**PLANNING COMMISSION STAFF REPORT
ADMINISTRATIVE ITEM**

**PLNPCM2010-00823
Sugar House Apartments
Building and Site Design Review
2025 & 2033 South 1200 East
March 9, 2011**

Applicant: Gardiner Properties

3RD LEVEL FLOOR PLAN (NORTH BLDG)
 Scale: 1/8" = 1'-0"

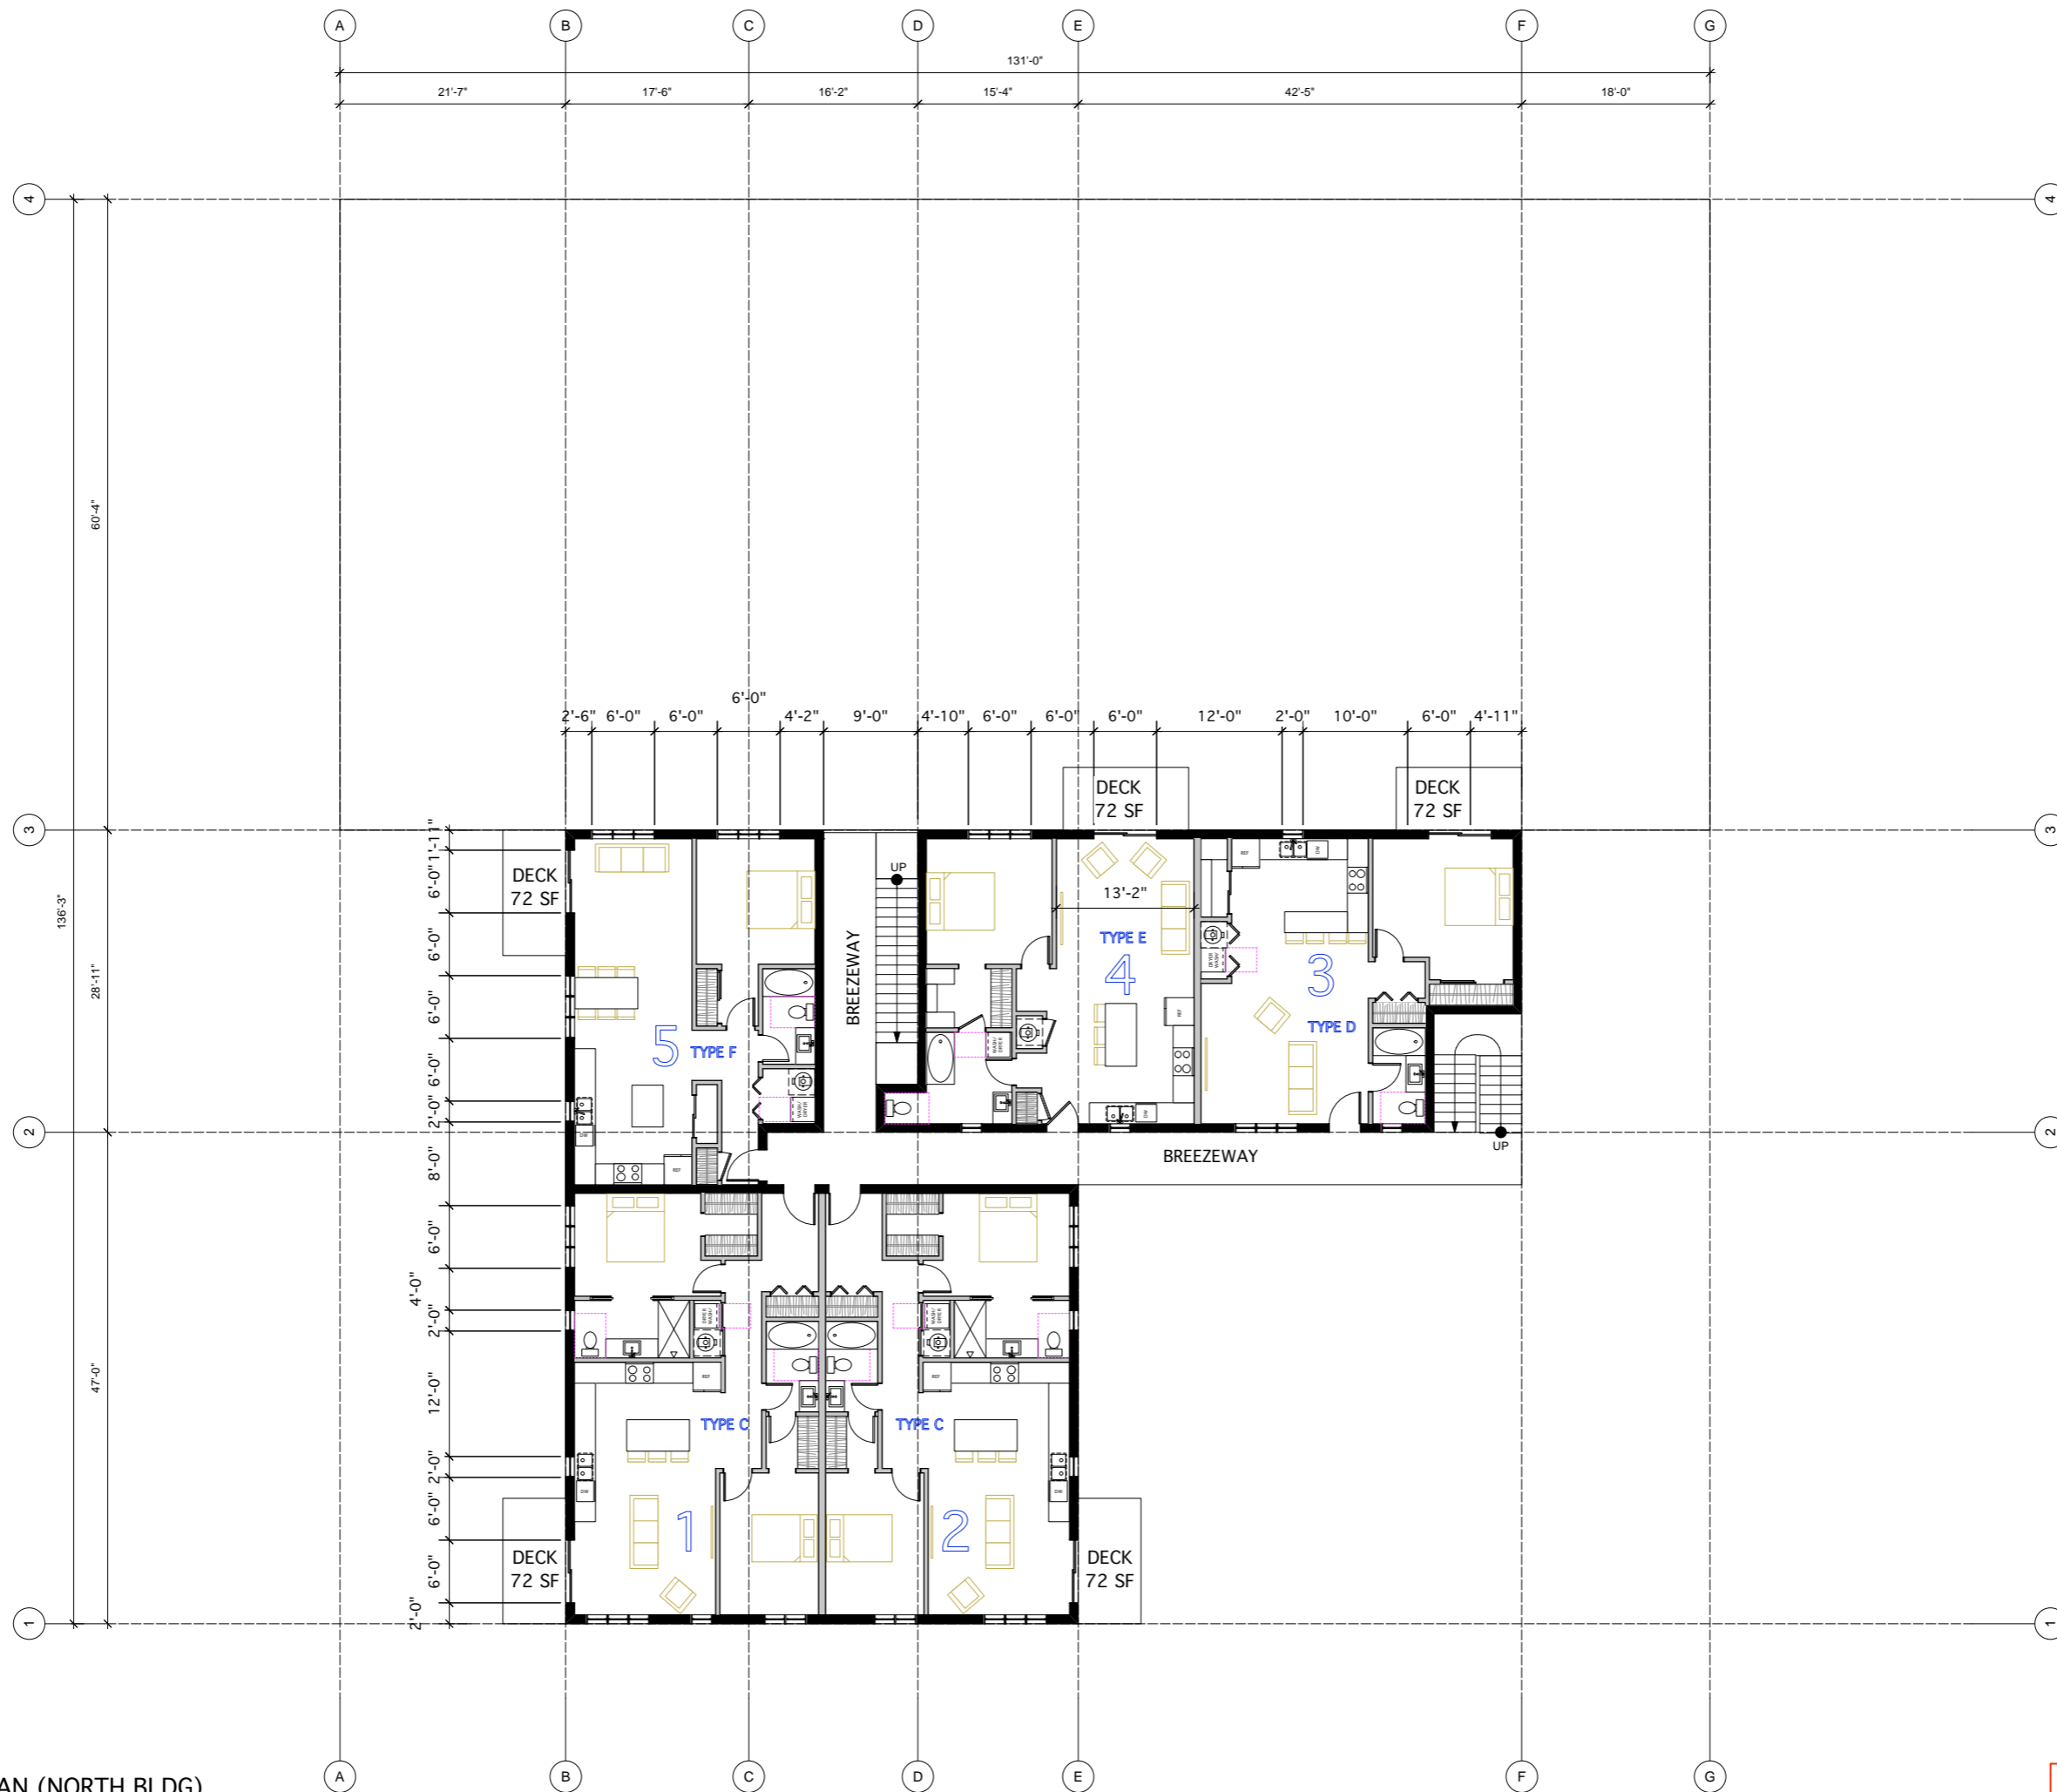
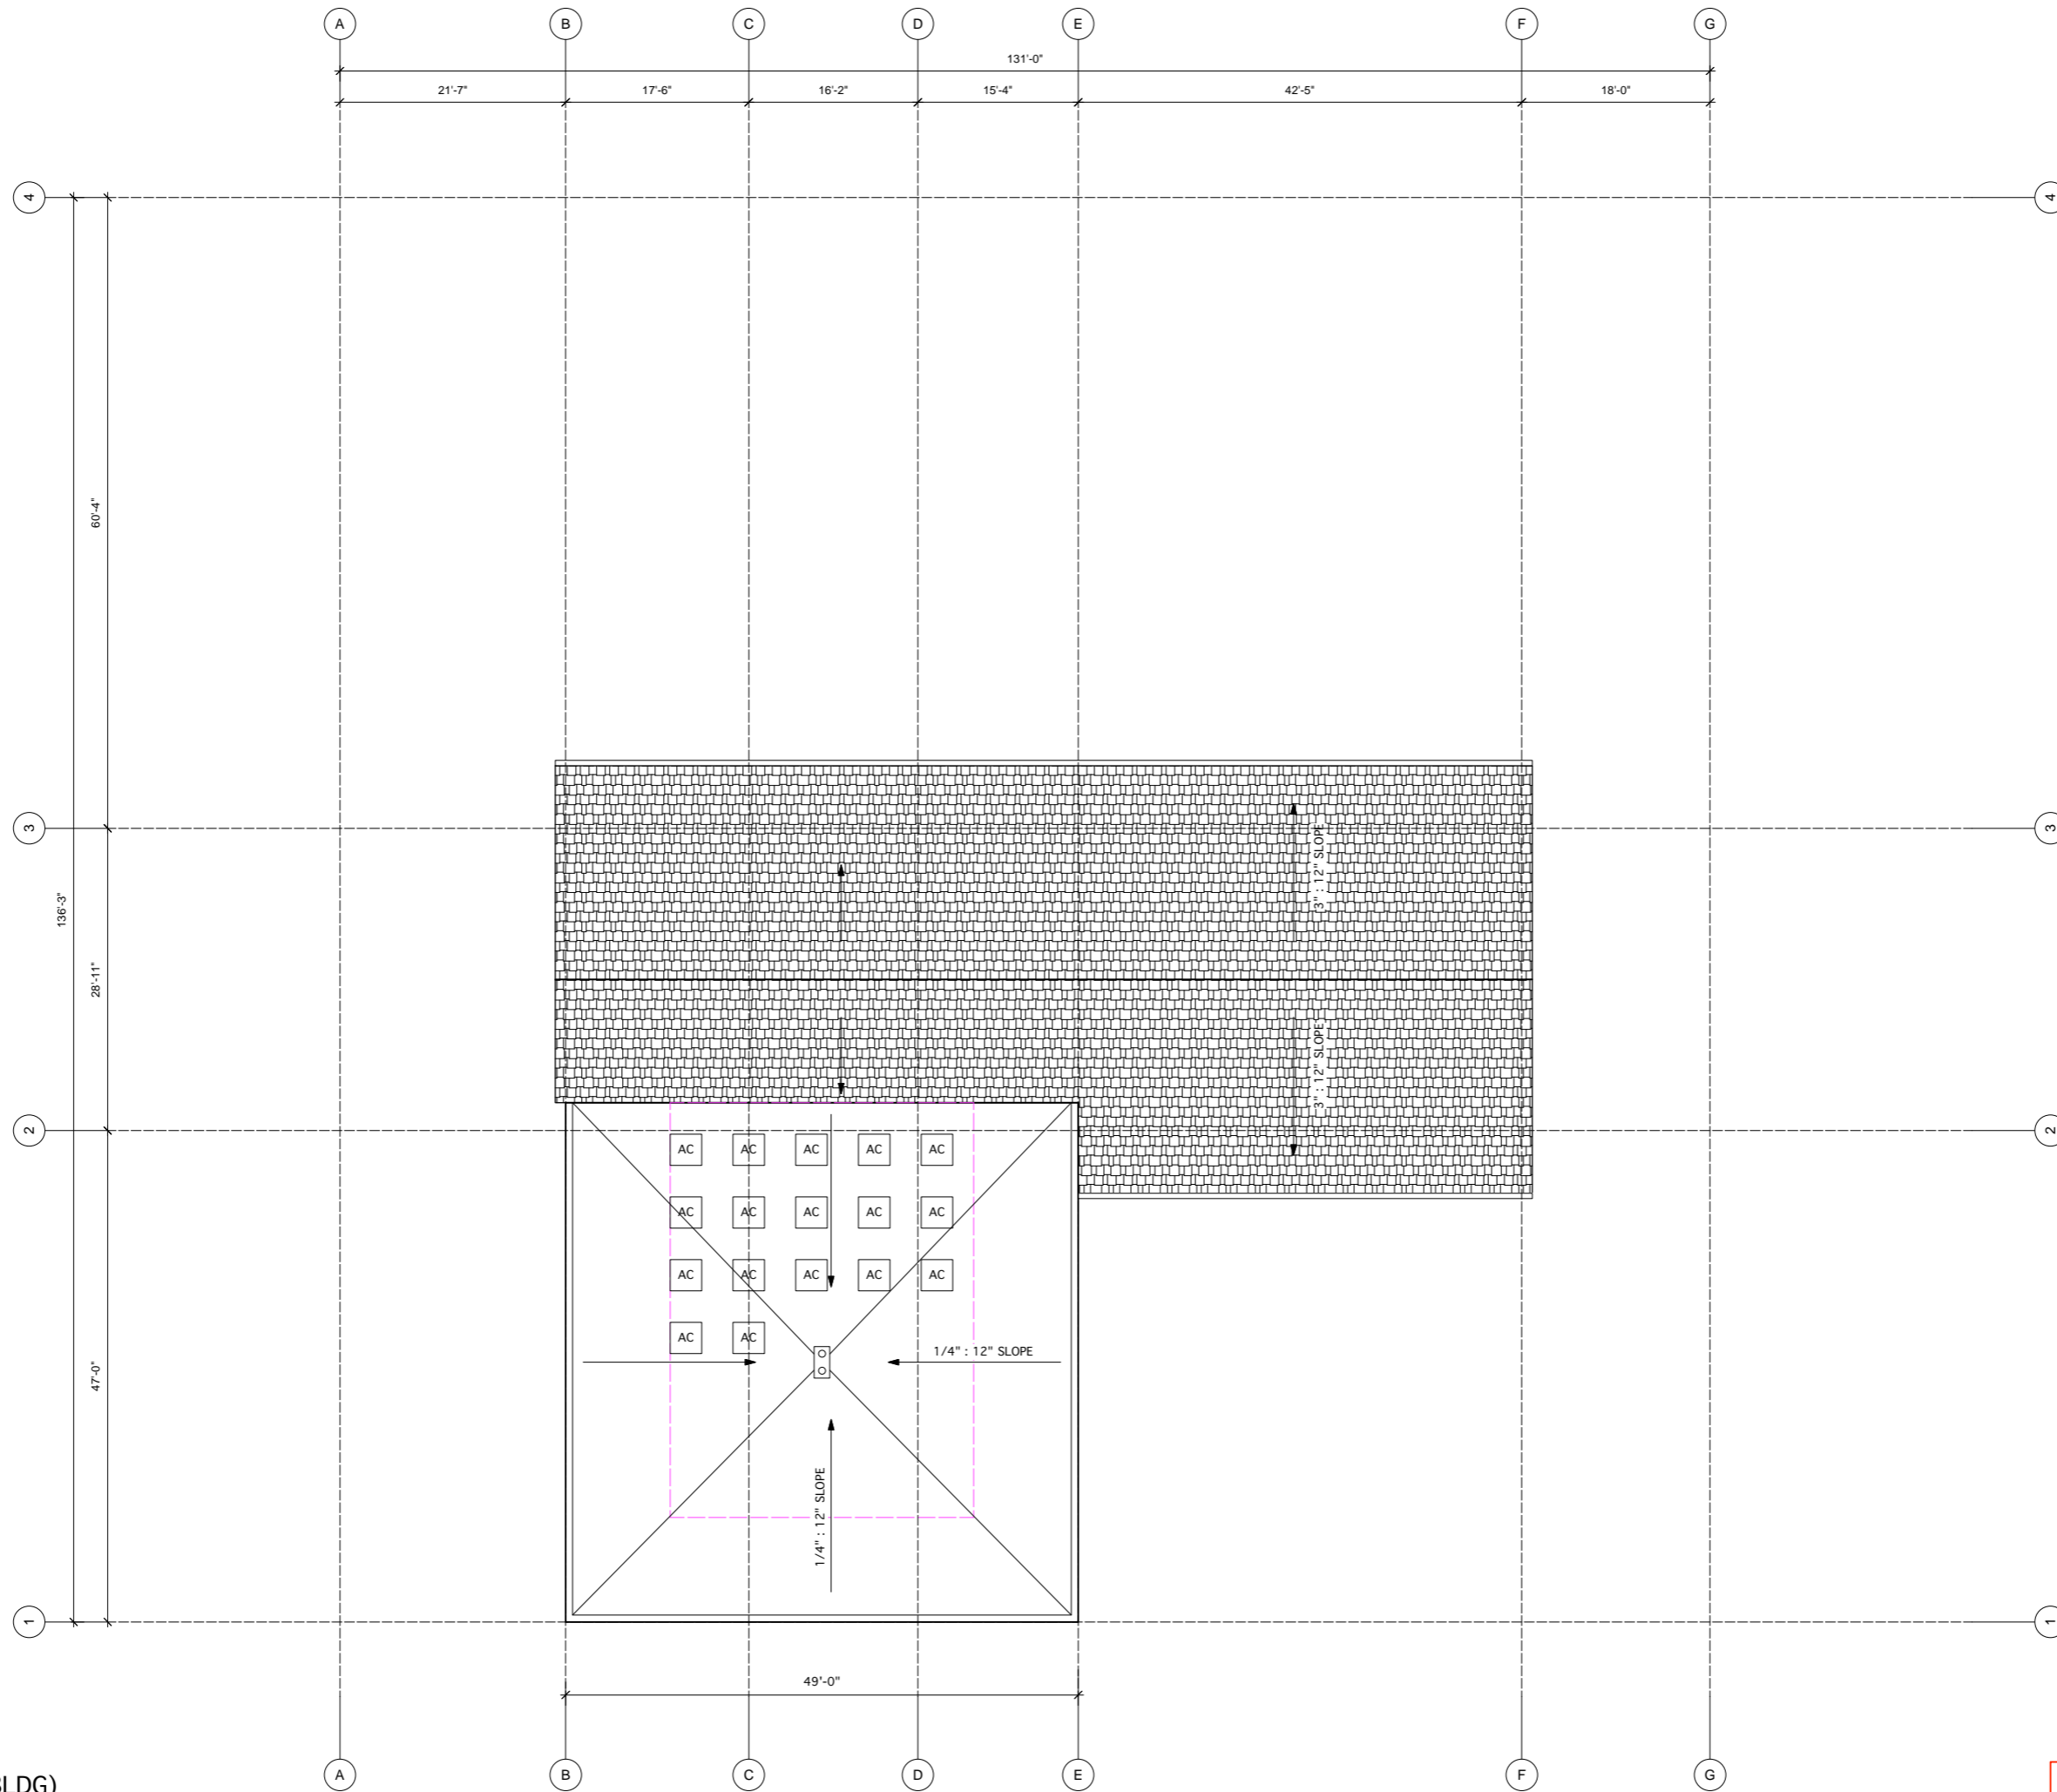
- How was the required handicap spaces calculated? (4 stalls per 0-99 are indicated on plans SLC code 21A.44.020.D)
- The building plans submitted for the north building need to be as detailed as the plans submitted for the south building. (Plans have been detailed see sheets AN1.1-1.4)
